DOMINION NUCLEAR CONNECTICUT, INC.
MILLSTONE POWER STATION UNIT 2
SIX-MONTH STATUS REPORT IN RESPONSE TO MARCH 12, 2012 COMMISSION
ORDER MODIFYING LICENSES WITH REGARD TO REQUIREMENTS FOR
MITIGATION STRATEGIES FOR BEYOND-DESIGN-BASIS EXTERNAL EVENTS
(ORDER NUMBER EA-12-049)

**Six-Month Status Report for the Implementation of Order EA-12-049, Order
Modifying Licenses with Regard to Requirements for Mitigation Strategies for
Beyond-Design-Basis External Events**

Millstone Power Station Unit 2

FIGURE 2 (FEBRUARY 2014 UPDATE)
 BDB FLEX STRATEGY
 MECHANICAL CONNECTIONS FLOW DIAGRAM
 MILLSTONE UNIT 2

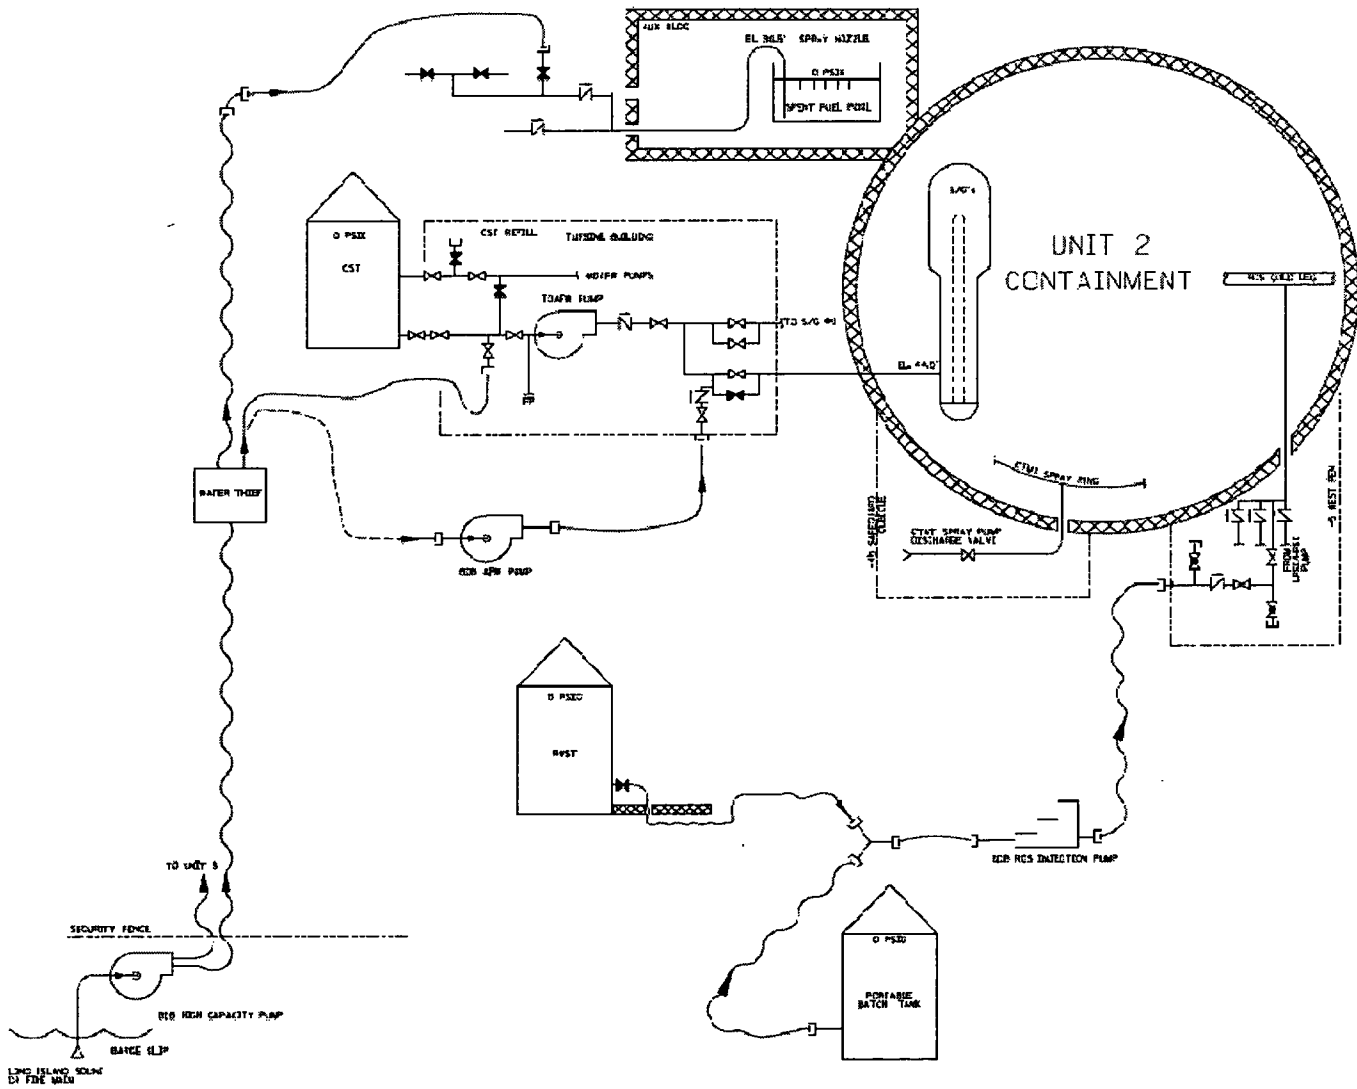
- g) The strategy has been revised regarding the flowpath for supplying water to the SGs following depletion of the contents of the CST. The CST has been removed from the flowpath once it is depleted. Attached is the revised OIP Figure 2 showing the updated connection strategy and flowpaths.

FIGURE 3 (FEBRUARY 2014 UPDATE)
 CORE COOLING AND DECAY HEAT REMOVAL
 MILLSTONE UNIT 2

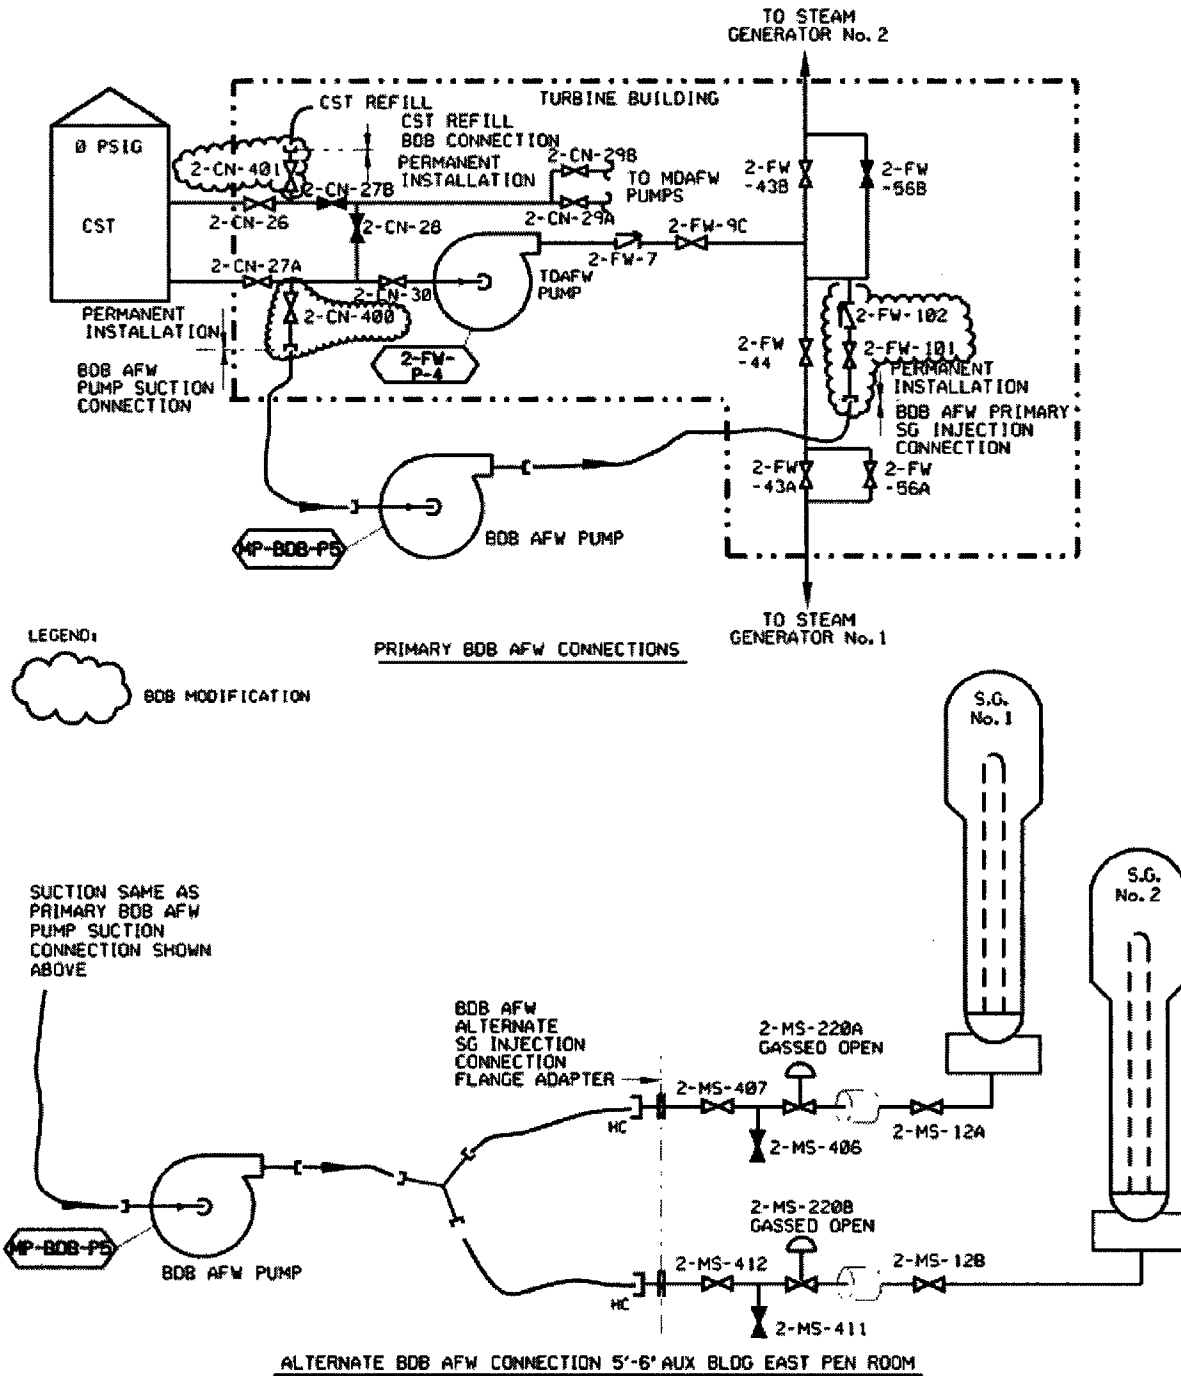
- c) The location and type of alternate connection for the BDB Auxiliary Feedwater (AFW) pump has changed. The discharge connection will no longer use the steam generator feedwater regulating bypass valves. Instead, the discharge connection will utilize a 2" flanged connection on the Steam Generator (SG) pump down skid. The connection is not seismically designed, but is at a location in the lower level of the Auxiliary Building which is a seismic, flood, and missile protected structure. The attached revised OIP Figure 3 shows this new AFW connection.

FIGURE 6 (FEBRUARY 2014 UPDATE)
ELECTRICAL GENERATOR DEPLOYMENT
MILLSTONE UNIT 2

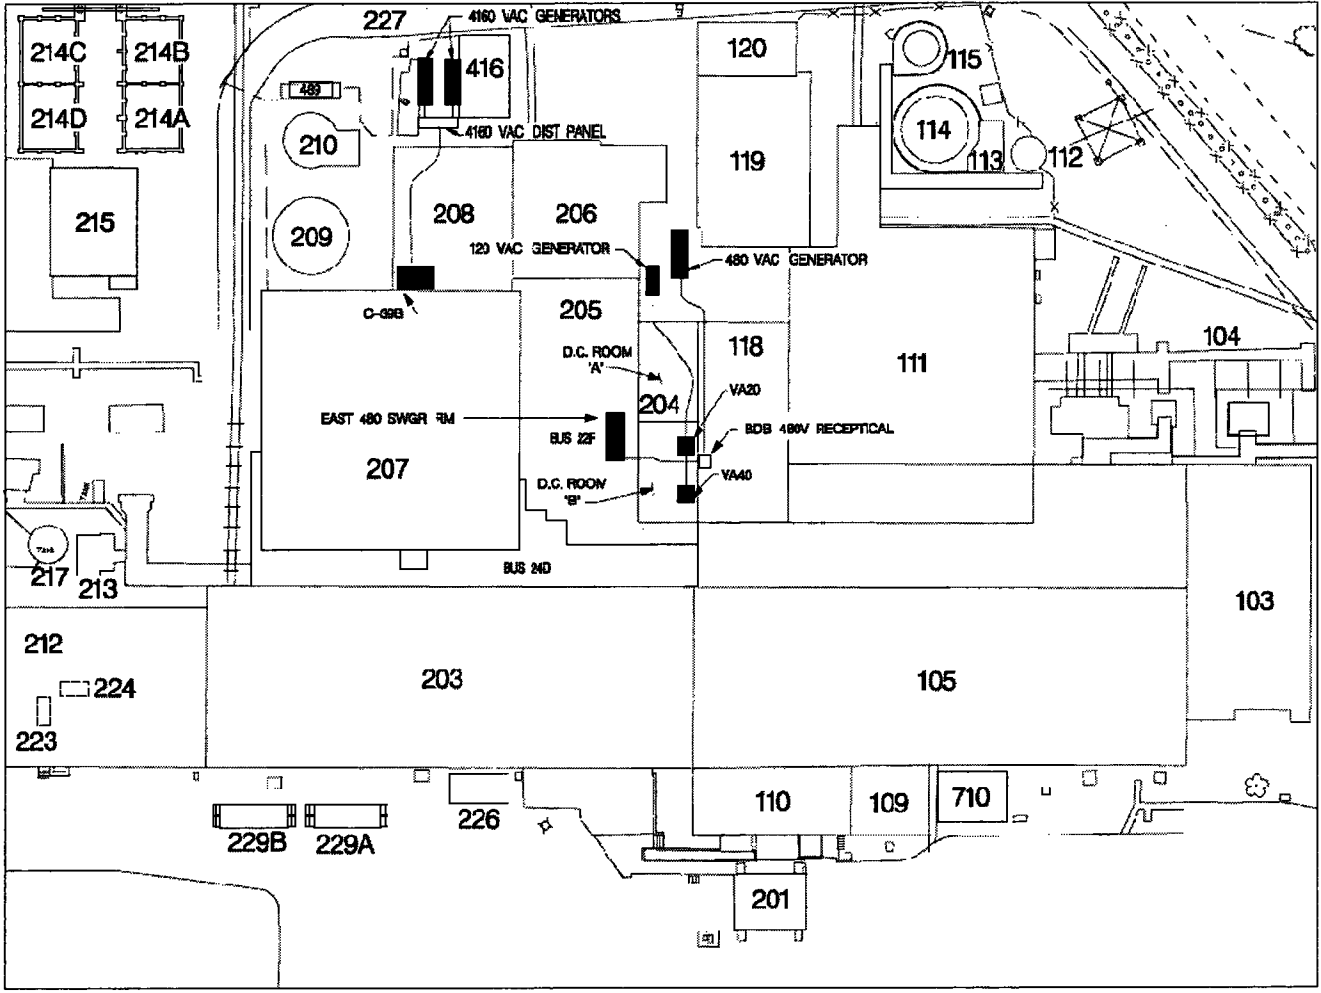
The deployment location of the 480VAC DG has changed. The attached revised OIP Figure 6 shows the new location in the courtyard east of the MPS2 DC Switchgear rooms. The attached revised OIP Figure 8 shows that the cable is now routed through the Millstone Power Station Unit 1 Cable Vault to a receptacle box permanently connected to Bus 22F.

The deployment location and cable routing for the 4160VAC DG have changed and now reflect a simpler tie-in into the 4160 Vital Bus 24D. This new configuration eliminated the need to tie into the non-vital 24A bus as previously presented. (This simplification is reflected in the revised response to Audit Question No. 42 in Attachment 3 to this letter.) The new tie-in is to a panel in the Emergency Diesel Generator (EDG) room. The leads from an existing (and non-operational) "B" EDG connection to Panel C39 will be lifted and the cables from the BDB 4160VAC DG will be connected in their place. The attached revised Figures 6 and 9 reflect the new deployment and cable tie-in locations.

FIGURE 7 (FEBRUARY 2014 UPDATE)
 120/240VAC GENERATOR ELECTRICAL CONNECTIONS
 MILLSTONE UNIT 2

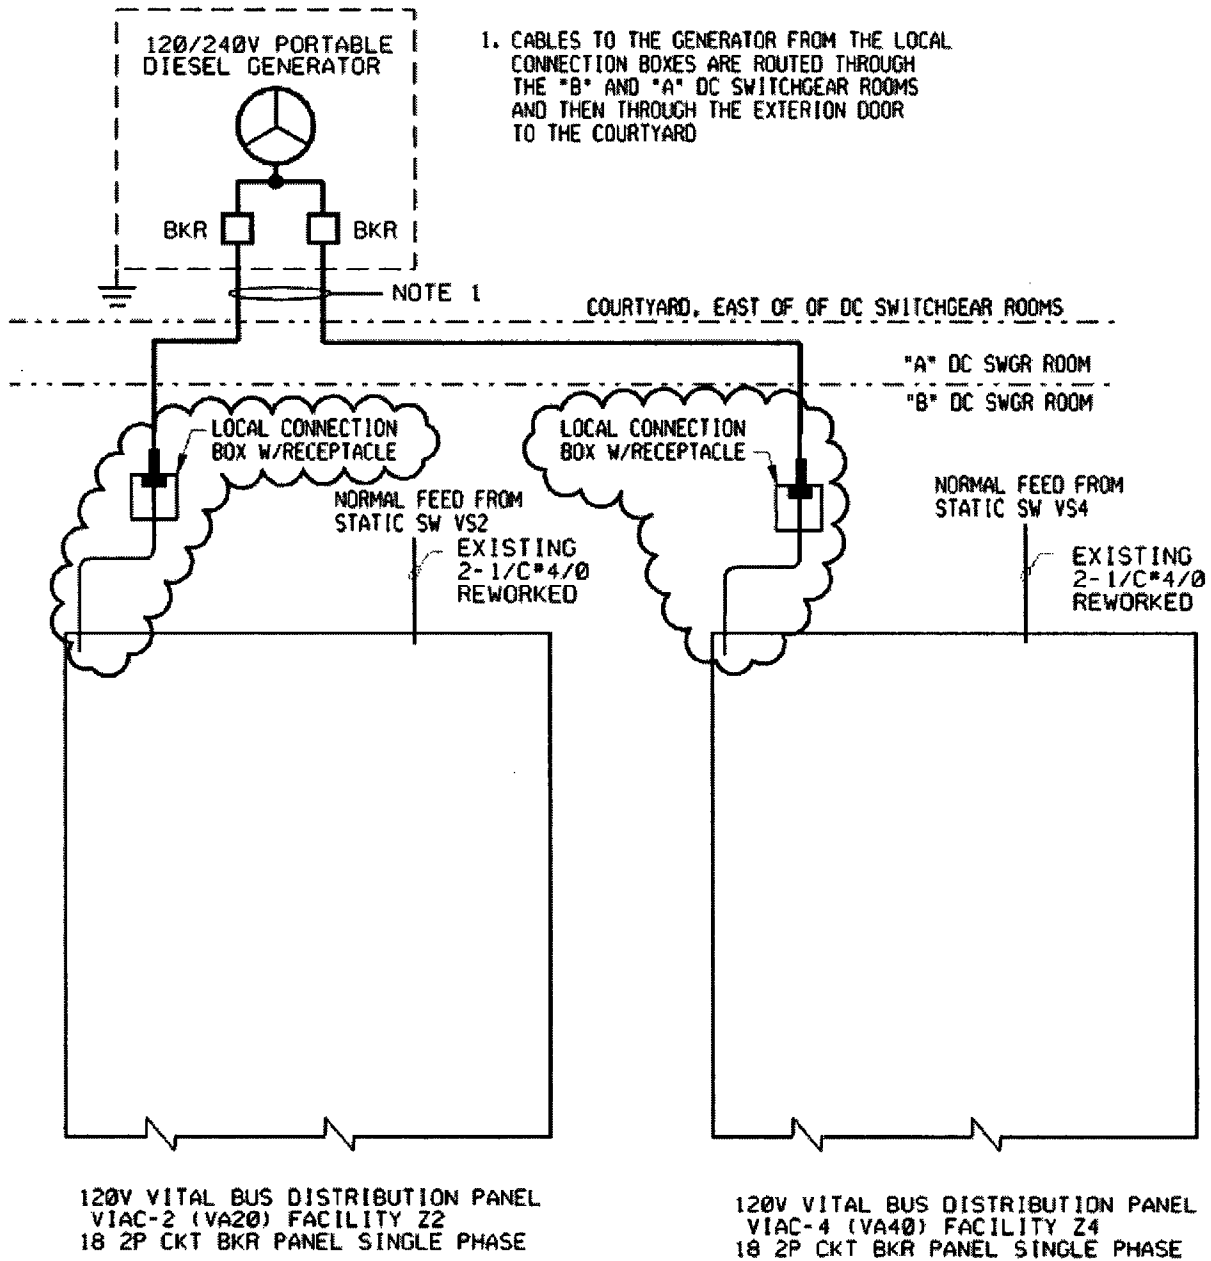
The deployment location of the single 120/240VAC DG shown in OIP Figure 6 has not changed. However, the cable routing and location of the connection receptacles has been revised. The attached revised OIP Figure 7 shows the updated configuration with the cable being routed through the “A” and “B” DC Switchgear rooms and connected to local receptacle boxes near the VA20 and VA40 Distribution Panels.

FIGURE 10
 CONTAINMENT COOLING
 BDB FLEX PRIMARY MECHANICAL CONNECTIONS
 MILLSTONE UNIT 2

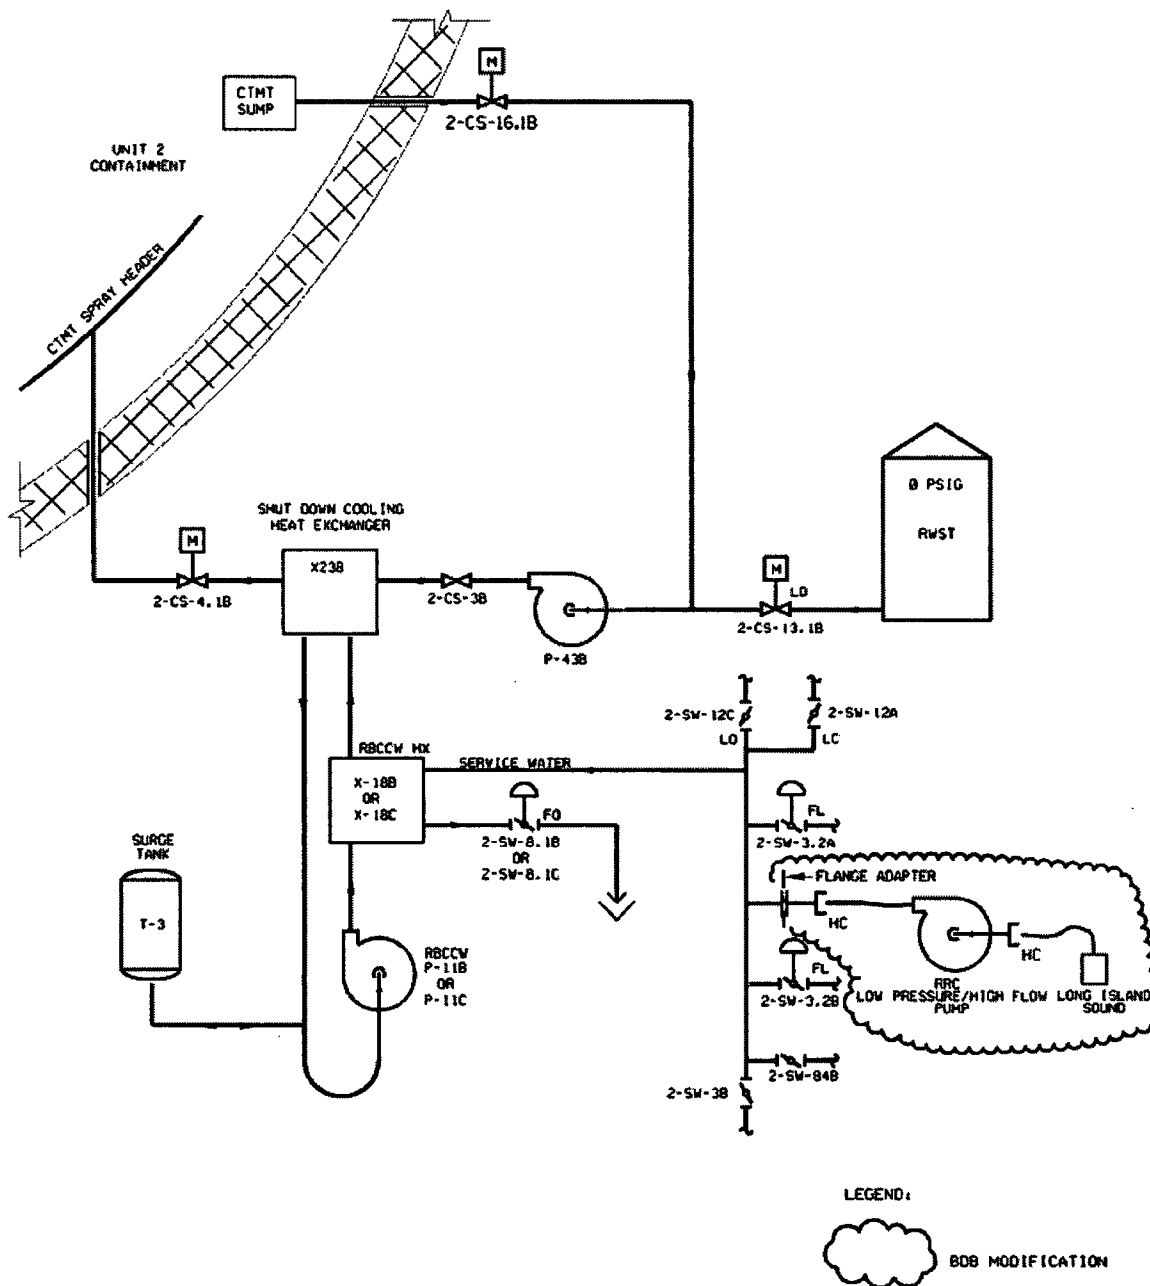
The Phase 3 Containment coping strategy was not provided in the initial submittal of the OIP. It is provided in Attachment 2 of this submittal. The Containment coping strategy is provided in the original OIP template format as Section D and is intended to supersede the previous Section D in its entirety. Attachment 2 also contains 2 new OIP figures (Figures 10 and 11) in support of the Section D Containment strategy.
